STC Modification Proposal Form

CM085: To clarify OFTO reactive power requirements at <20% output

Figure ECC.6.3.2.4(c)

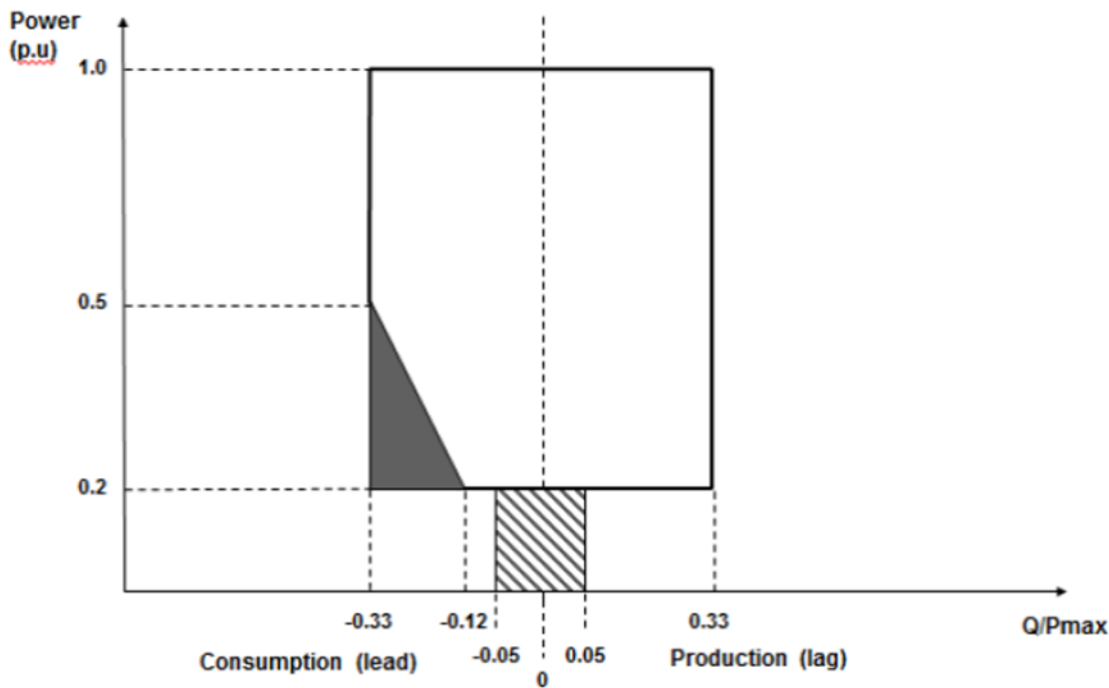
This diagram sets out the expected operating envelope for a power park module in terms of its reactive range at varying active power outputs, being expressed as a maximum requirement (the thick black line) down to 20% of active power output. Further details are in the text (ECC6.3.2.4.4) which accompanies the diagram.

The two shaded areas are not within the expected requirement for PPMs and there is not a definitive reactive requirement below 20% output for PPMs although ECC.6.3.8.4.1 states:

'When operating below 20% Maximum Capacity the automatic control system may continue to provide voltage control using any available reactive capability. If voltage control is not being provided, the automatic control system shall be designed to ensure a smooth transition between the shaded area below 20% of Active Power output and the non-shaded area above 20% of Active Power output.'

Figure K1

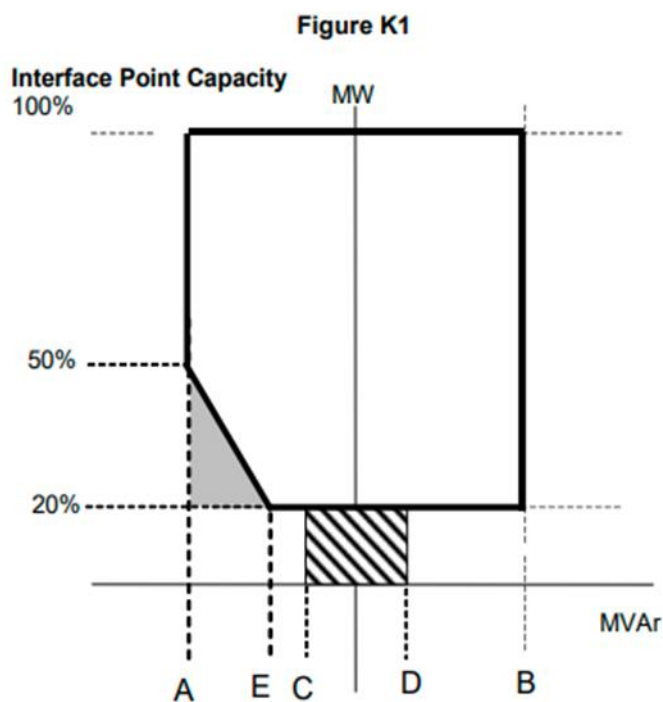
2.4 When transferring Active Power equivalent to less than 20% of the Interface Point Capacity:

2.4.1 the automatic control system may continue to provide voltage control utilising any available reactive capability and, if applicable, as instructed by The Company *where this can be achieved without unduly affecting such equipment. For the avoidance of doubt this is not an absolute design requirement;*

2.4.2 If voltage control is not being provided:

(a) the automatic control system shall be designed to be capable of a smooth transition between the shaded area bounded by CD and the non-shaded area bound by AB in Figure K1 below; and

(b) the Reactive Power delivered at the Interface Point shall be within a range of +/-5% of the Interface Point Capacity expressed in MVar.
